BOARD OF TRUSTEES
REGULAR MEETING AGENDA

September 12, 2018
7:00 PM
151 Grant Avenue
Firestone, CO 80520

- 8.a. Proposed Final Plat and Final Development Plan for Cottonwood Hollow, F1
Resolution 18-31: A RESOLUTION APPROVING A FINAL PLAT AND FINAL DEVELOPMENT PLAN FOR COTTONWOOD HOLLOW, FILING 1
- 8.b. Proposed Revised Final Development Plan for Phase 2 of Gateway North-Multi Family
RESOLUTION 18-33: A RESOLUTION APPROVING A FINAL DEVELOPMENT PLAN FOR GATEWAY NORTH - MULTI-FAMILY (PHASE 2)
- 8.c. Proposed Final Plats and Final Development Plan for St Vrain Ranch Subdivision F3A and St Vrain Ranch Subdivision F5A
Resolution 18-34: A RESOLUTION APPROVING FINAL PLATS AND FINAL DEVELOPMENT PLANS FOR ST VRAIN RANCH FILINGS 3A AND 5A

SHEET INFORMATION
C-1.0

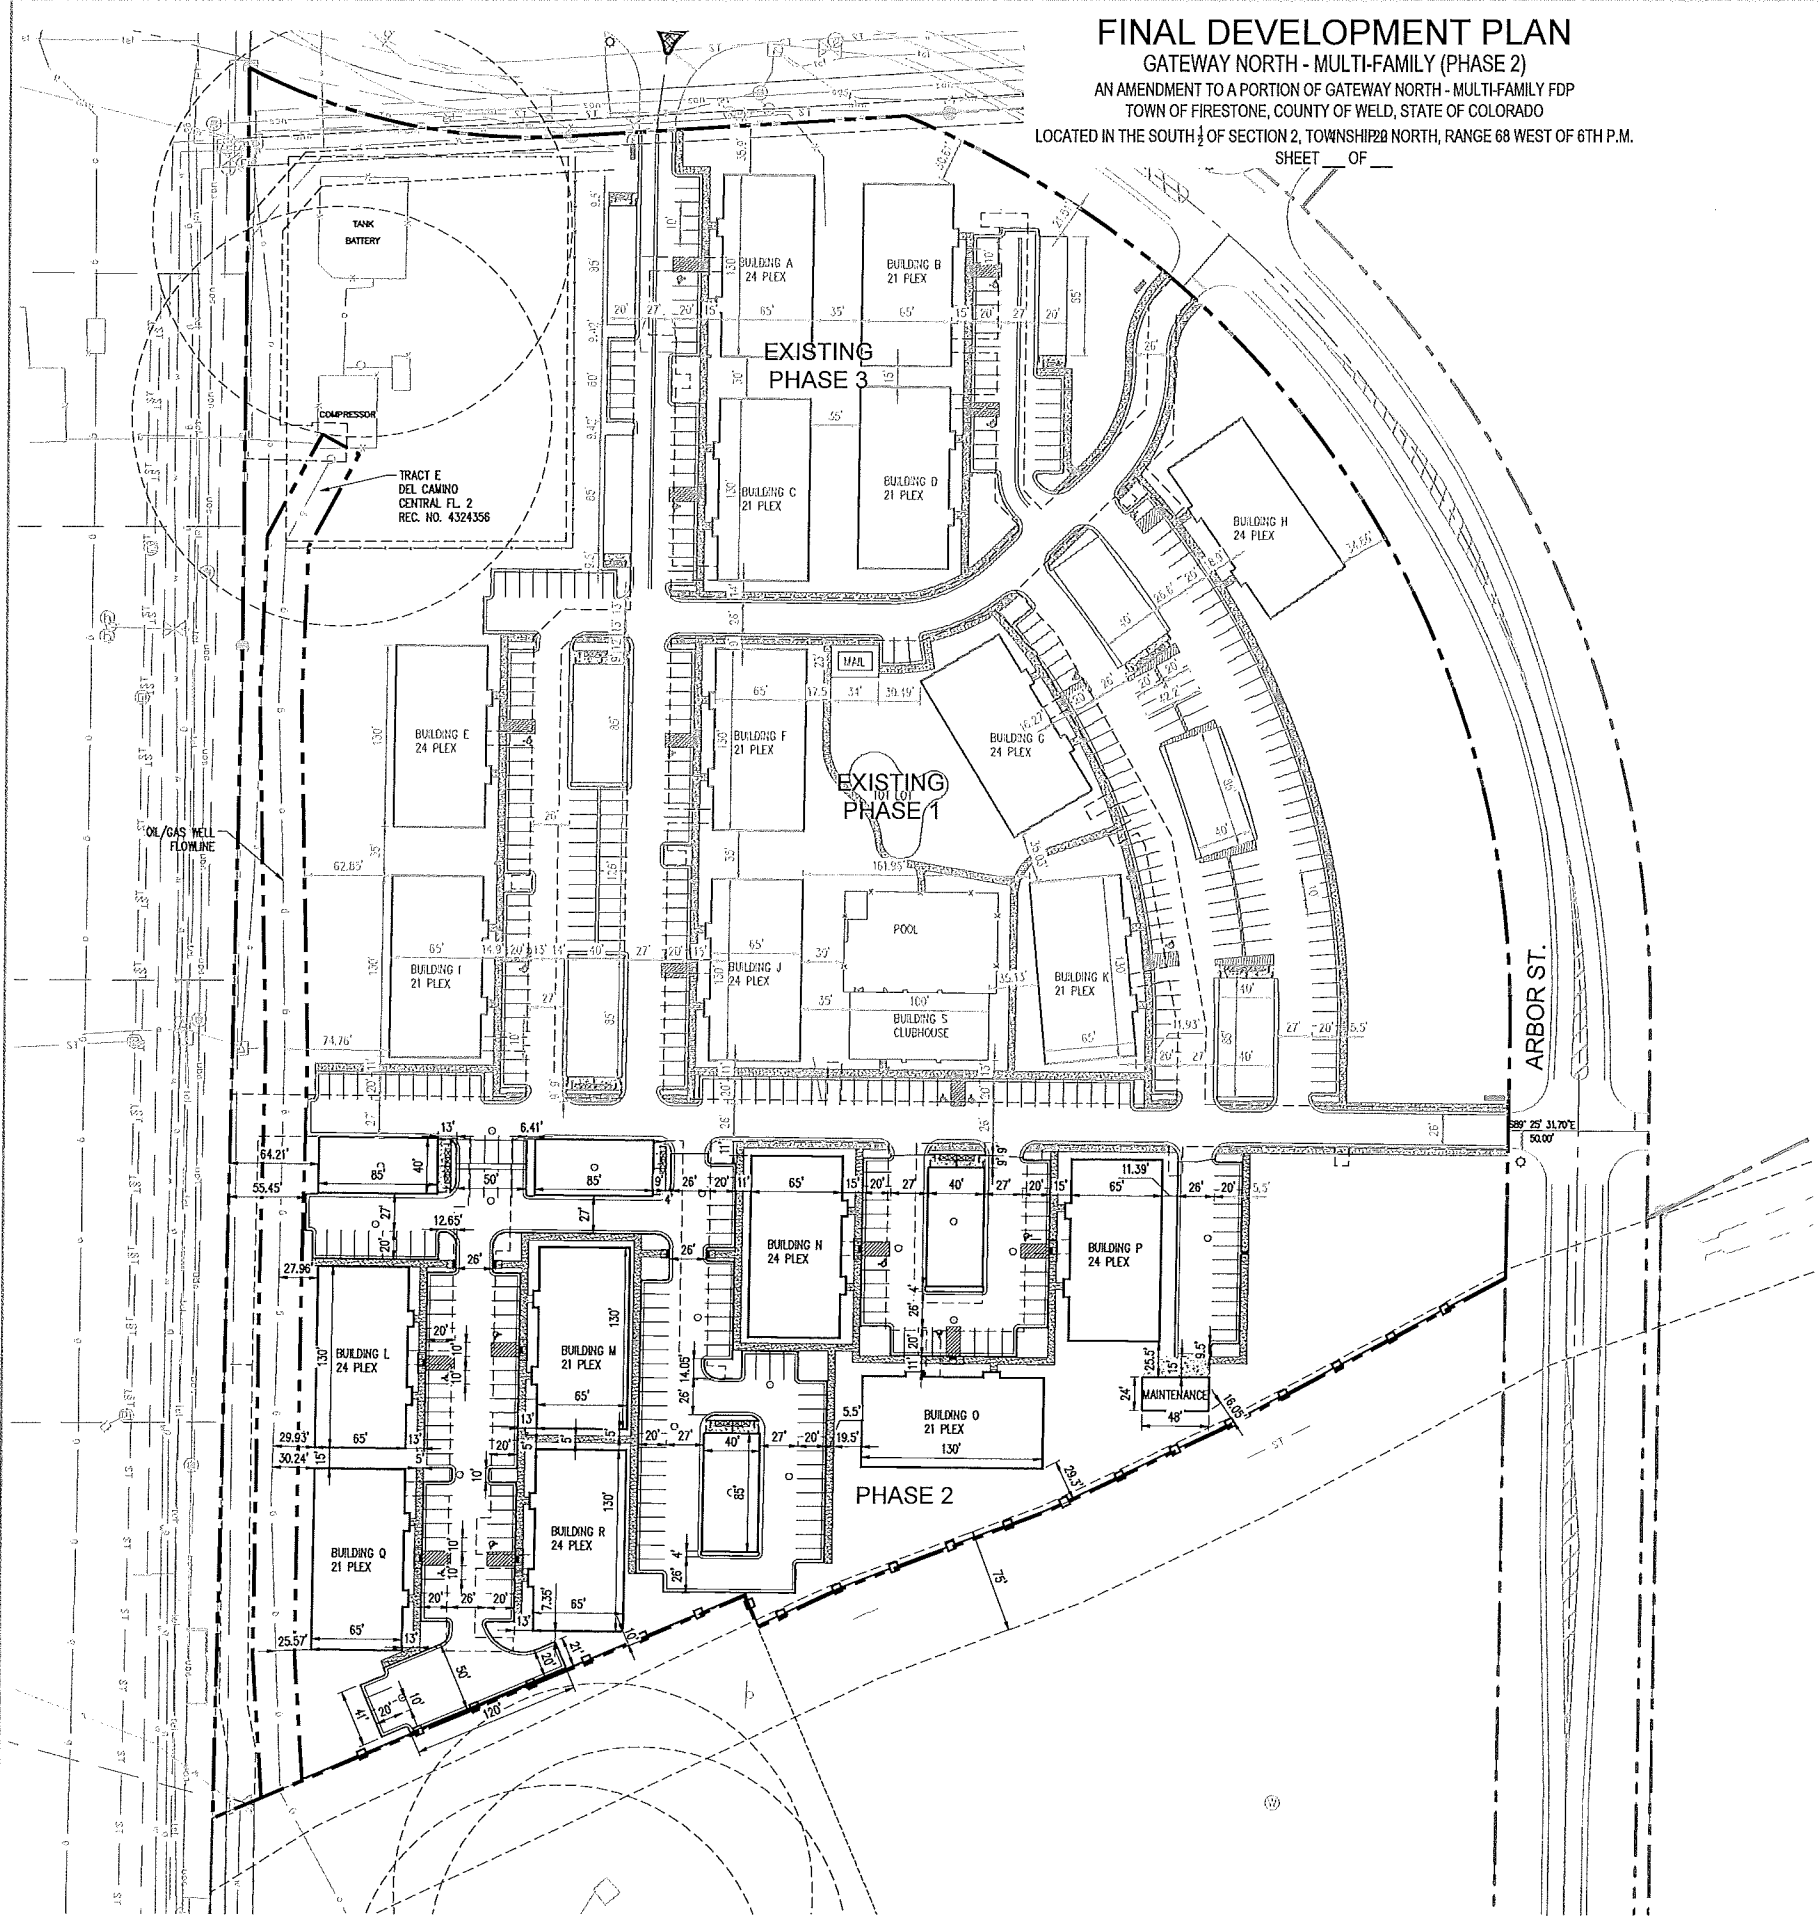
FDP Sheet 3 (Overall Site Plan)

SHEET INFORMATION
C-1.1

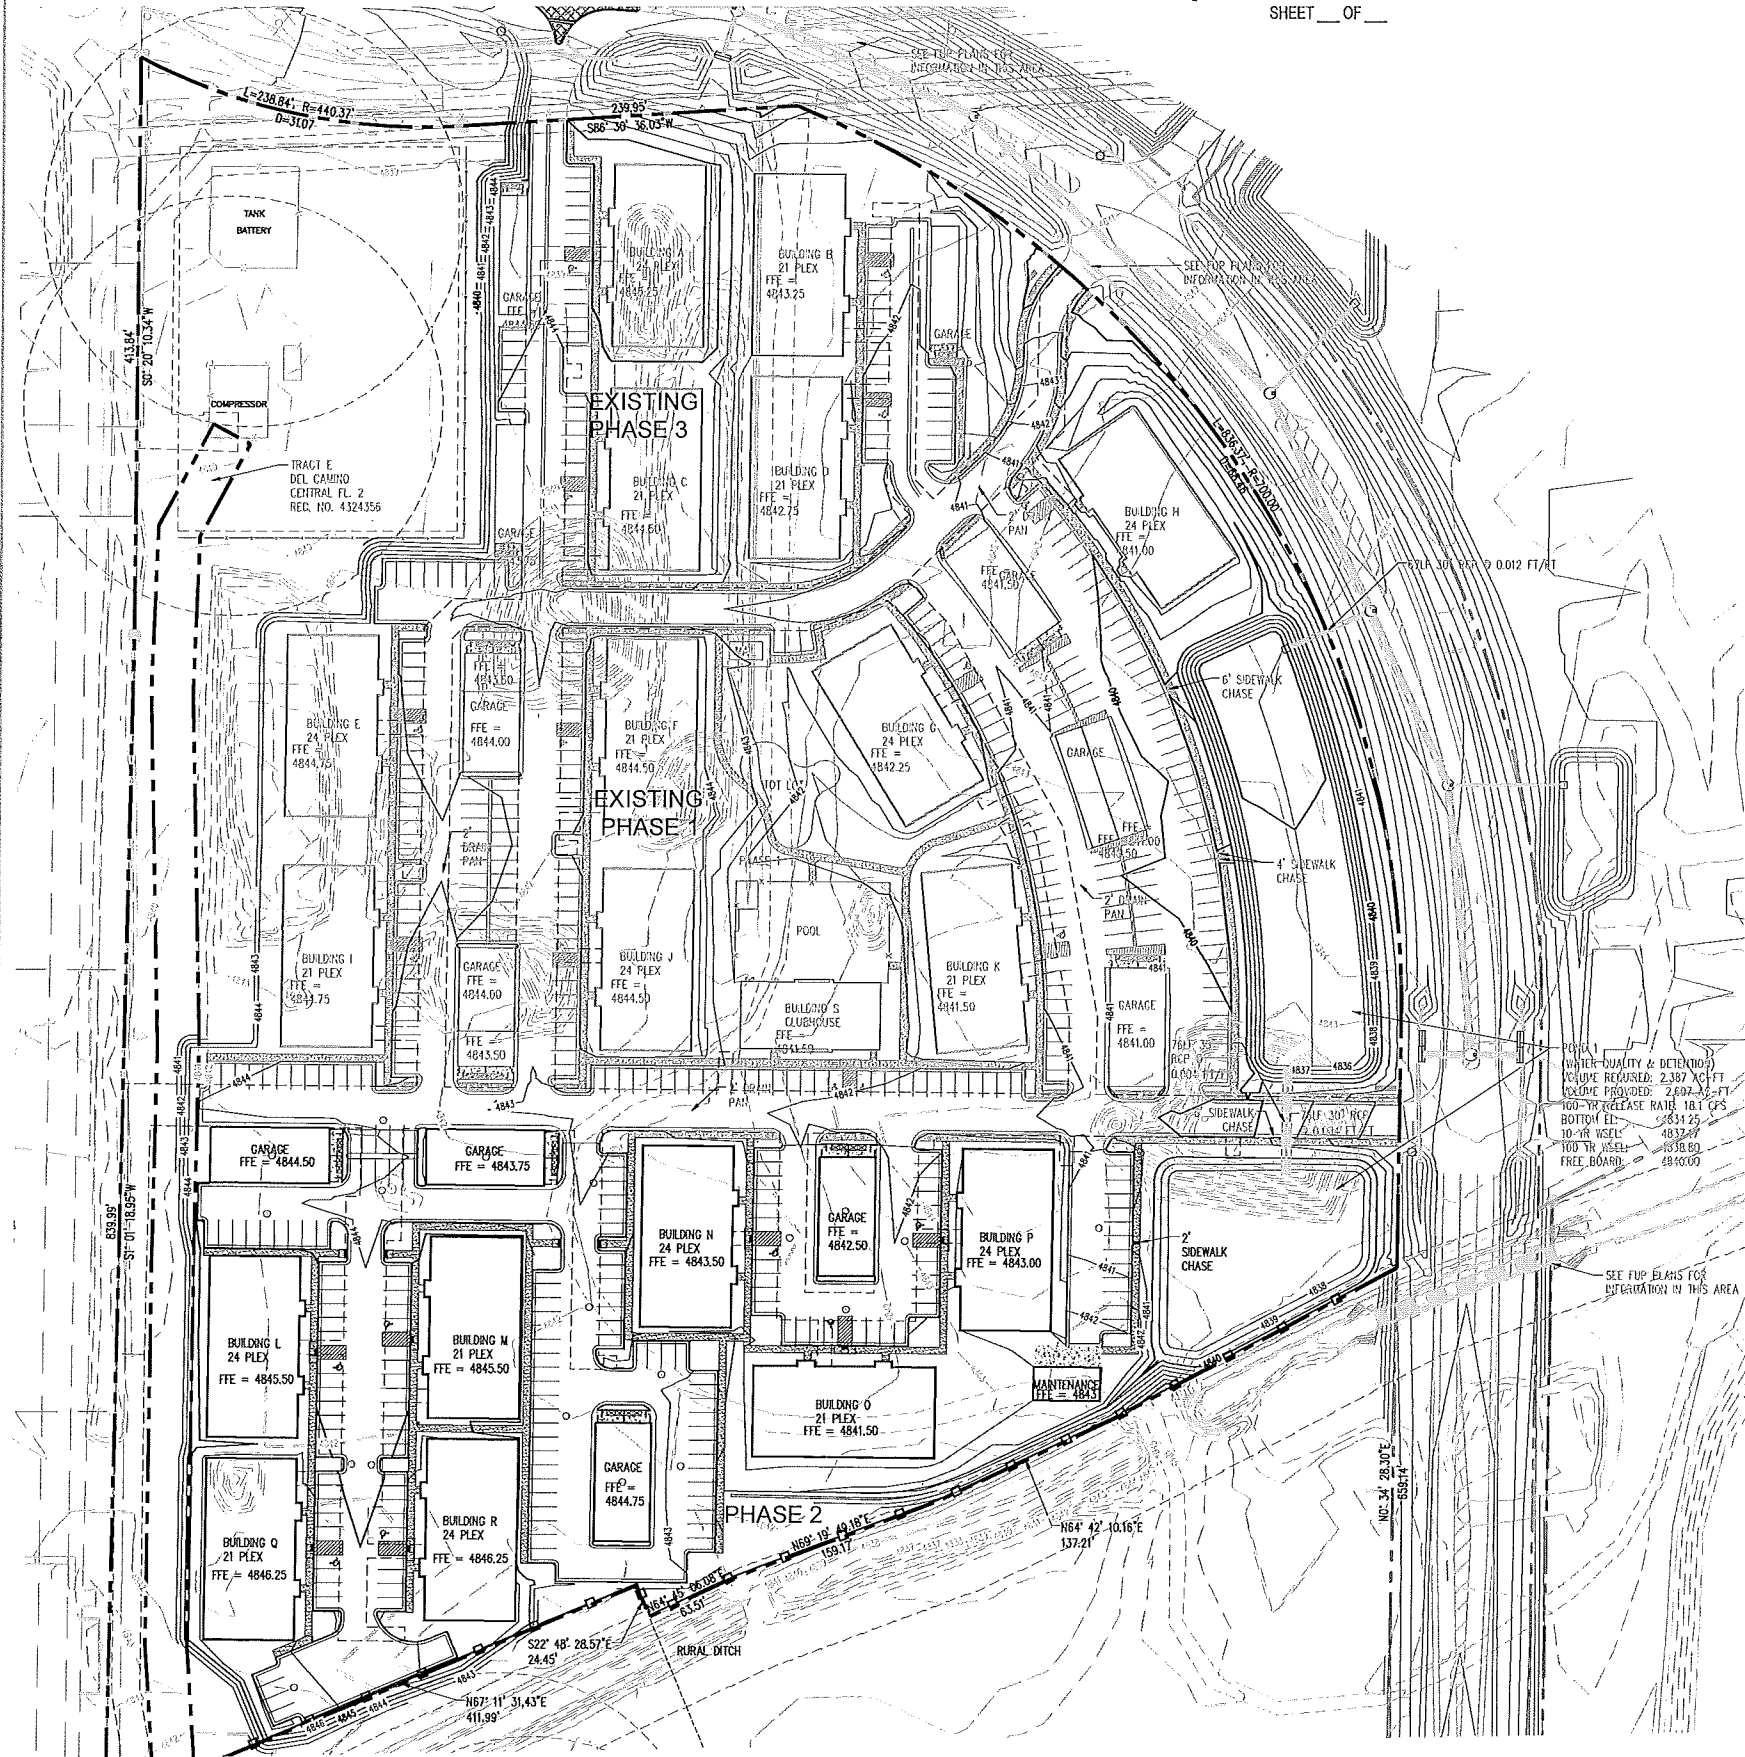
FDP Sheet 4 (Horizontal Control Plan)

24. On Sheets 4-7, revise Phase 2 dimensions, text, and utility symbols from faded back to bold or normal pen weight text.

SHEET INFORMATION
C-3.0

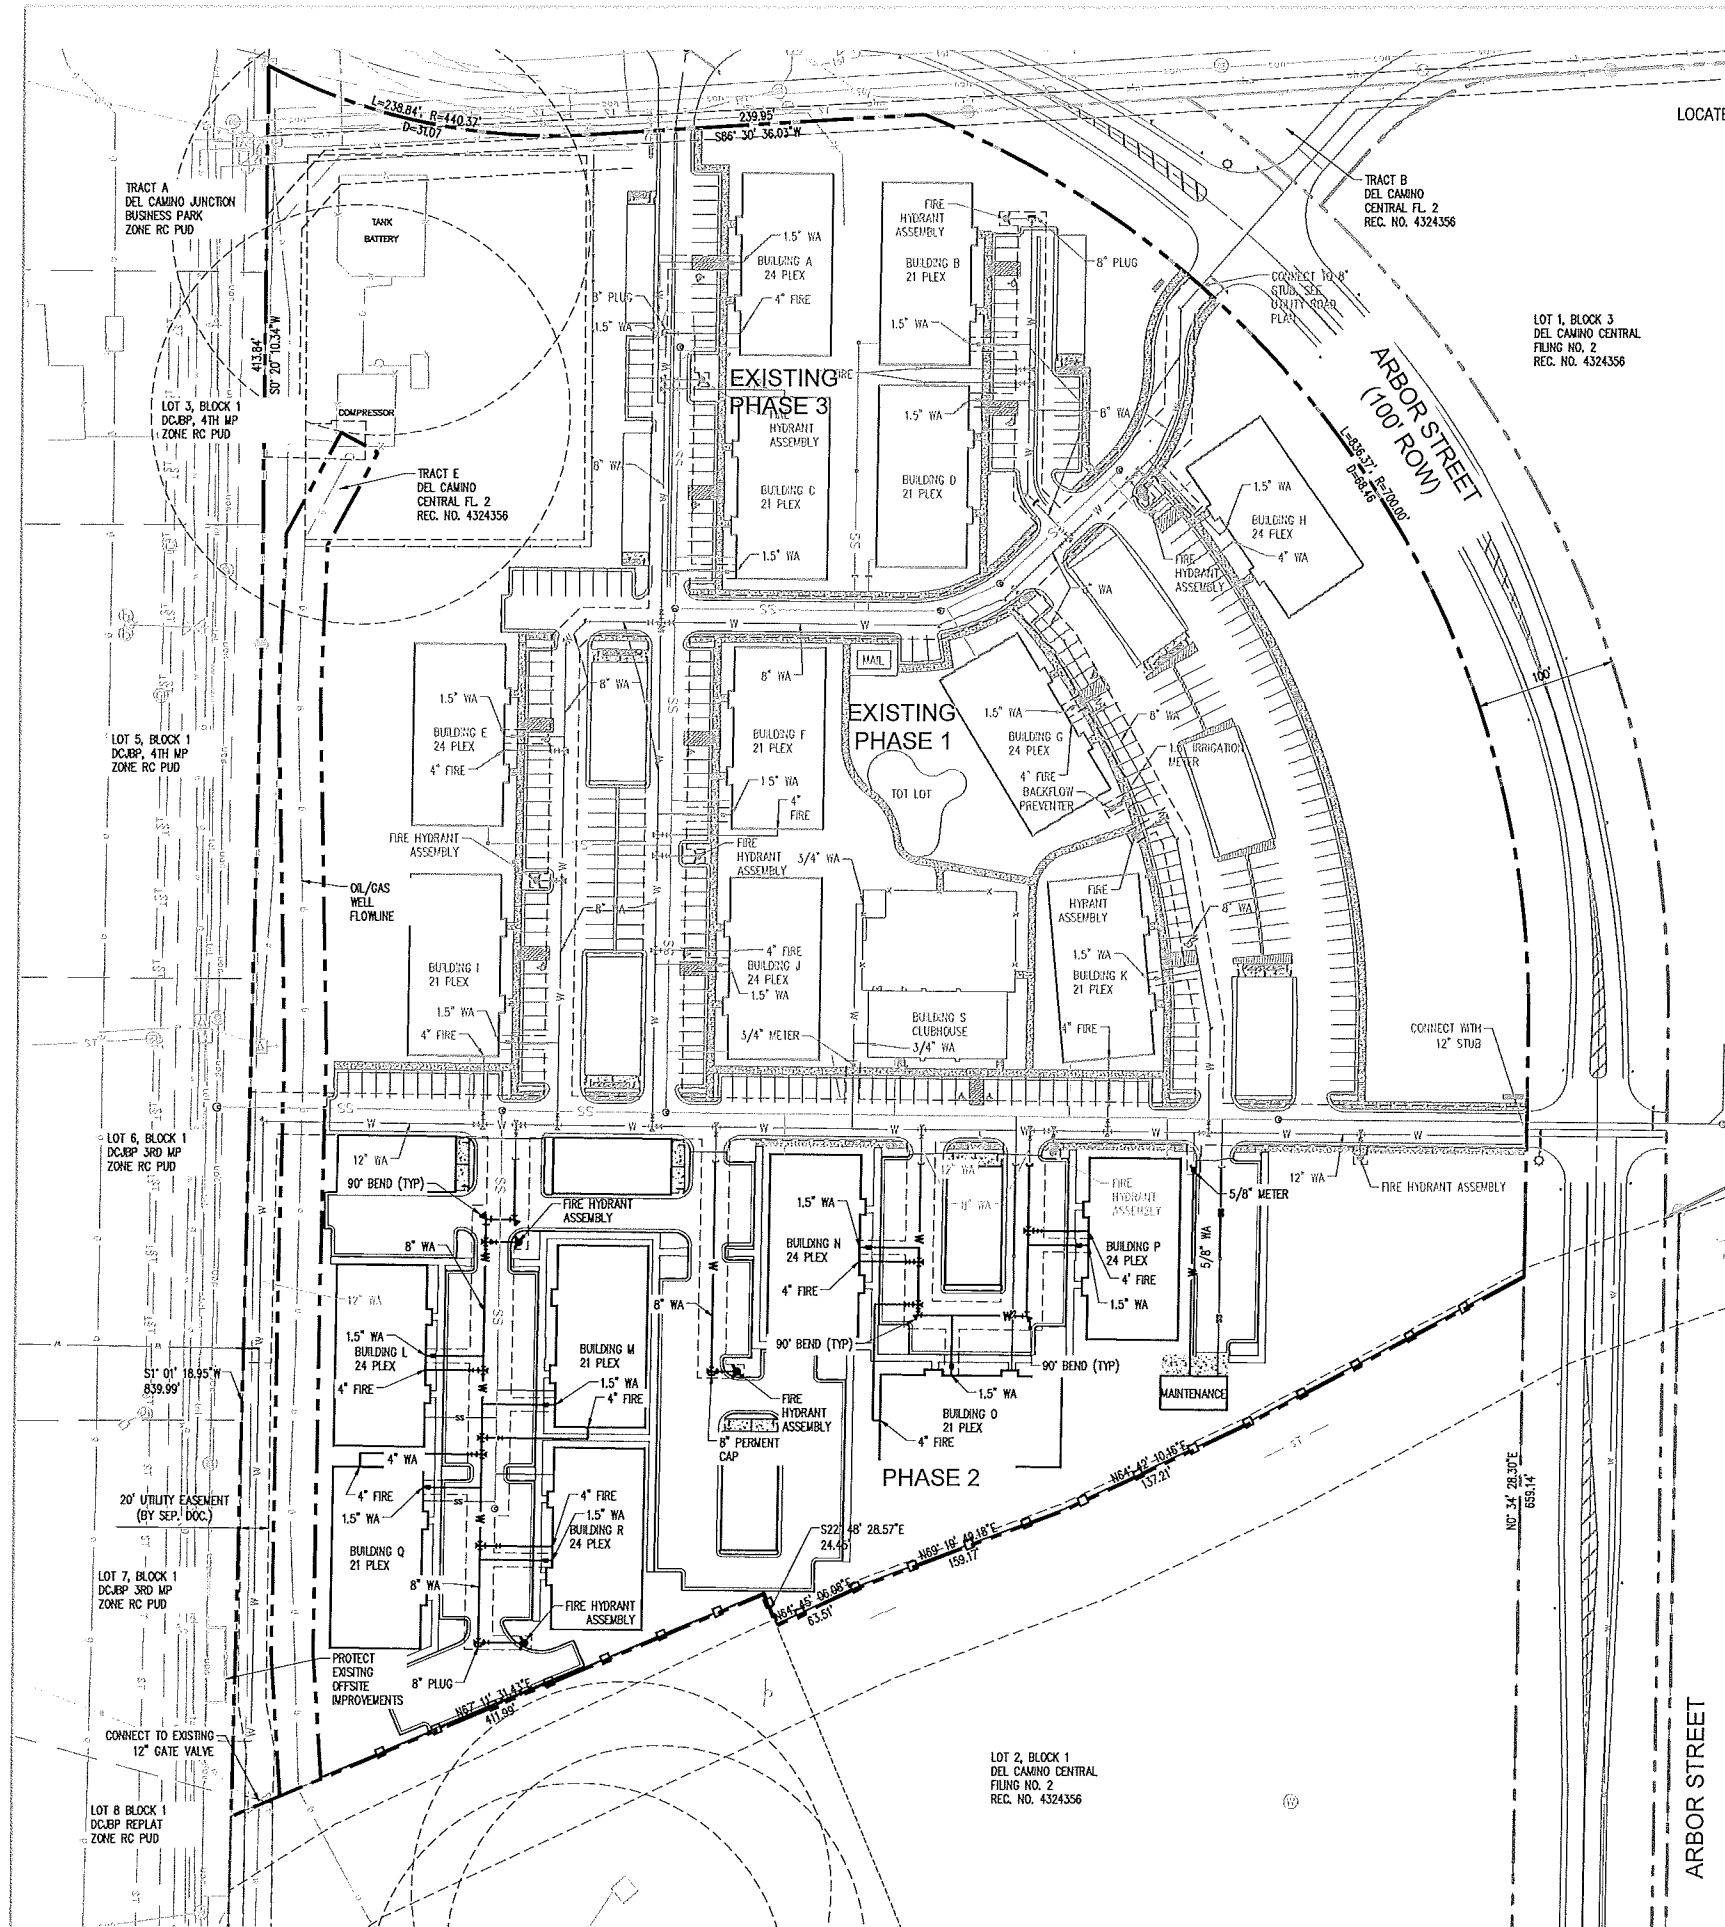
FDP Sheet 6 (Overall Utility Plan)
